St. Lucie Unit 2
Docket No. 50-389
Proposed License Amendment
Core Operating Limits Report (COLR)

ATTACHMENT 3 to L-97-280

ST. LUCIE UNIT 2 MARKED-UP TECHNICAL SPECIFICATION PAGES

ALLOWABLE COMBINATIONS OF THERMAL POWER AND F_r^T , F_{xy}^T

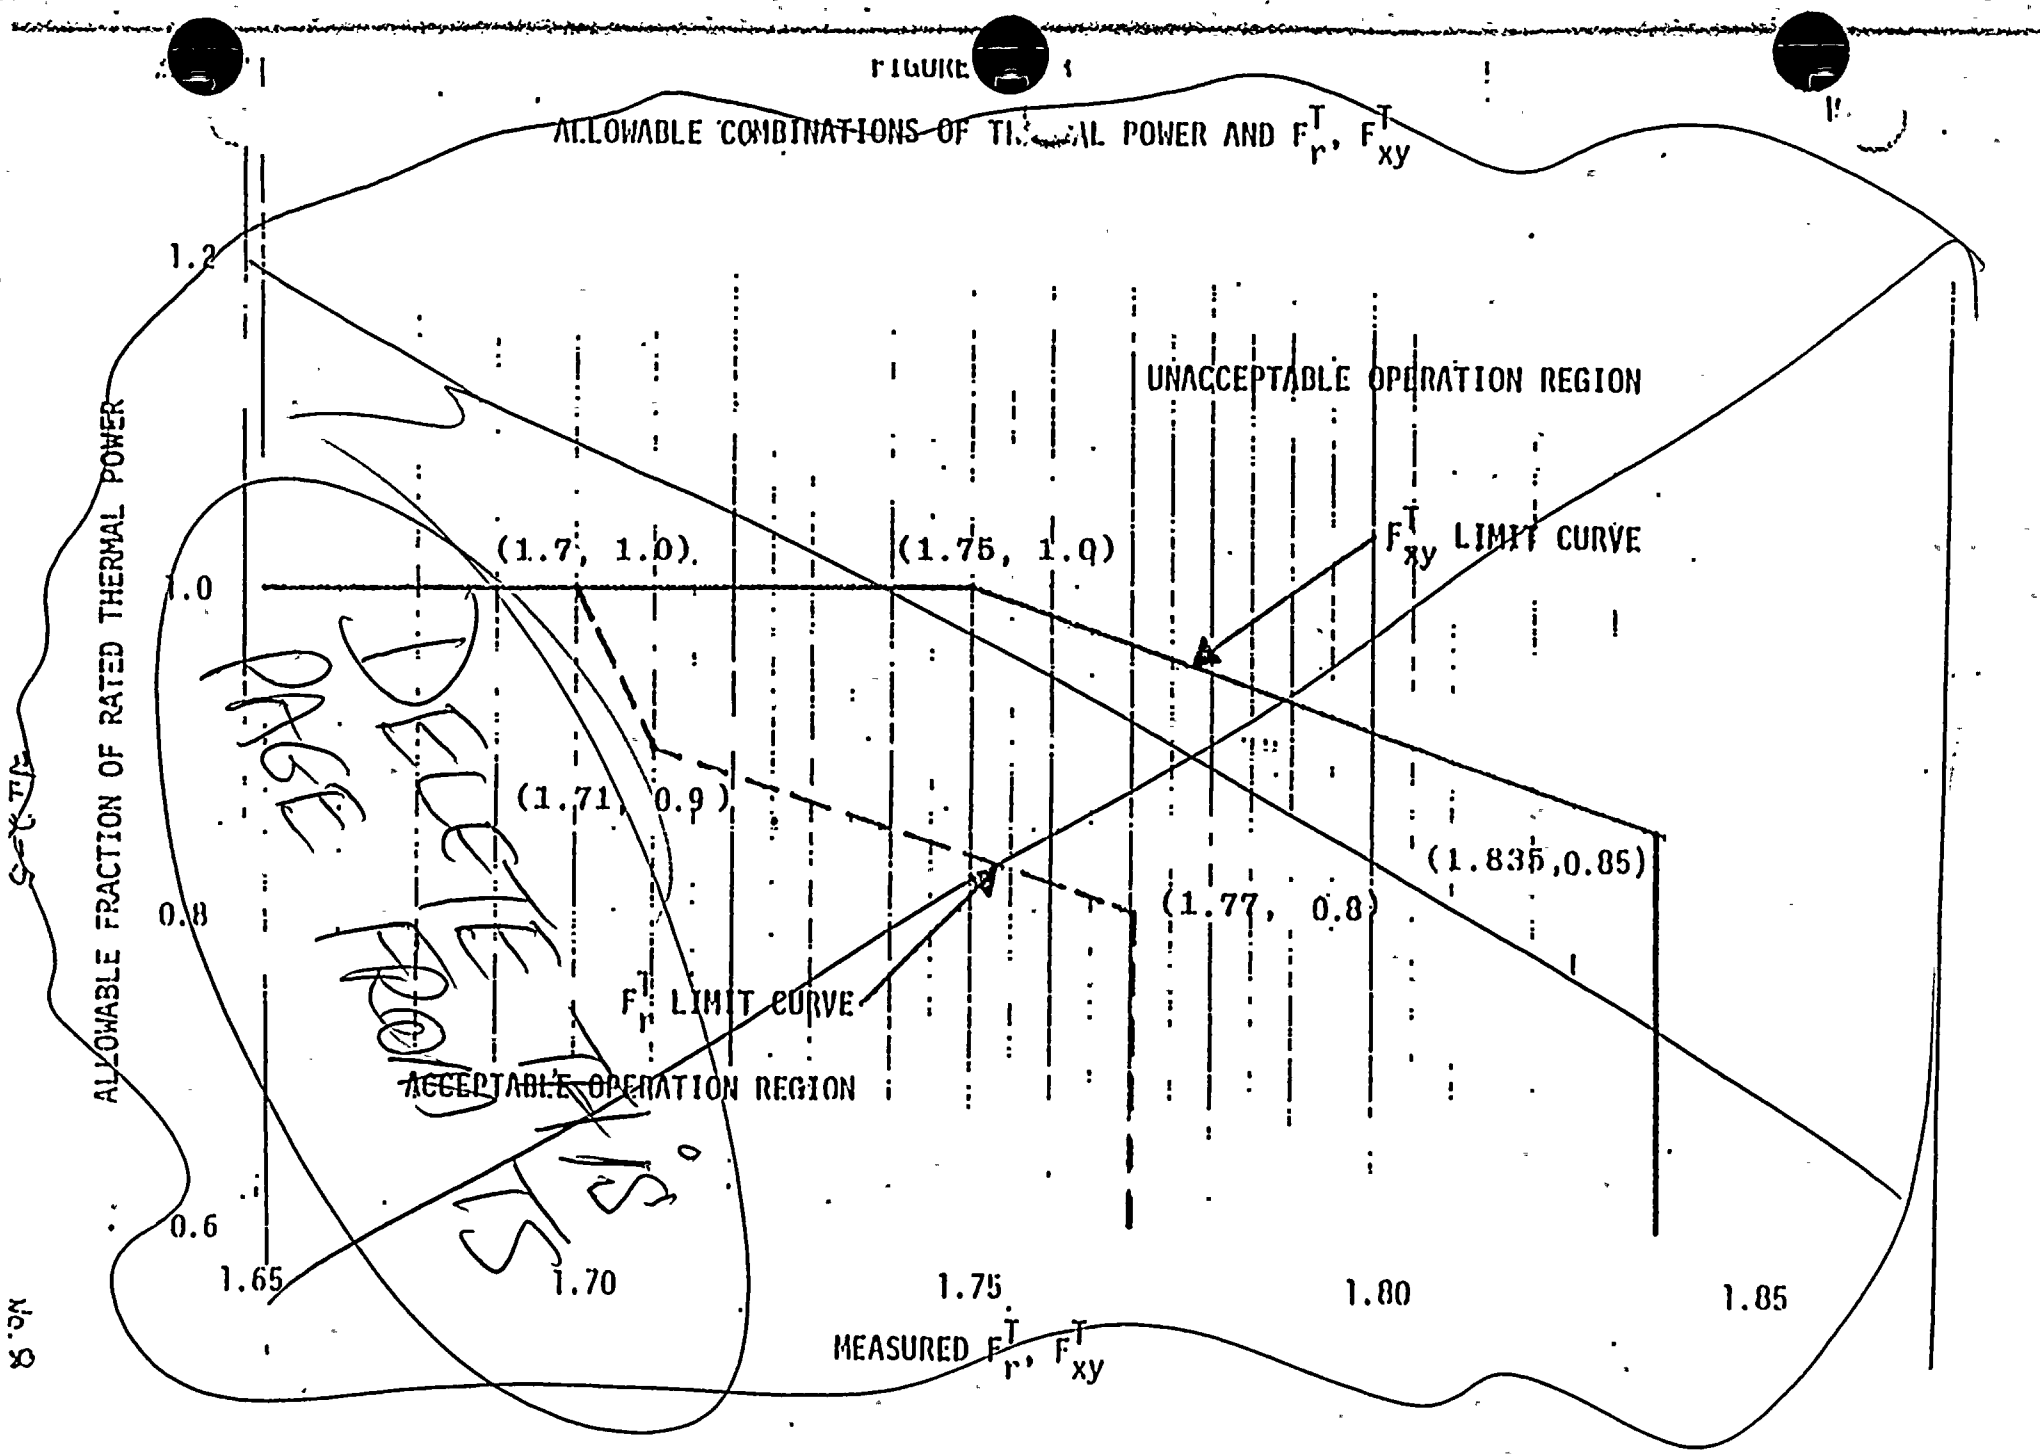
DELETE THIS PAGE
FROM TS

FIGURE 3.2-4

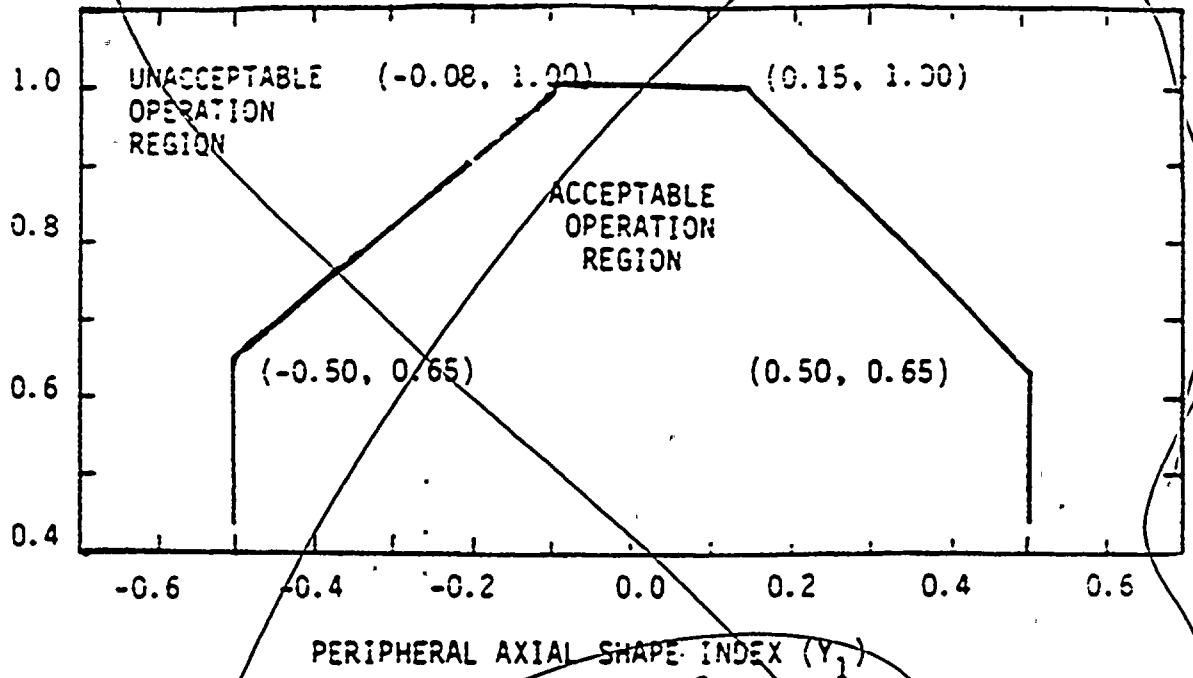
Page 3/4 2-12 (Amendment 42) has been deleted from the Technical Specifications. The next page is 3/4 2-13.

DELETE THIS PAGE FROM T.S.
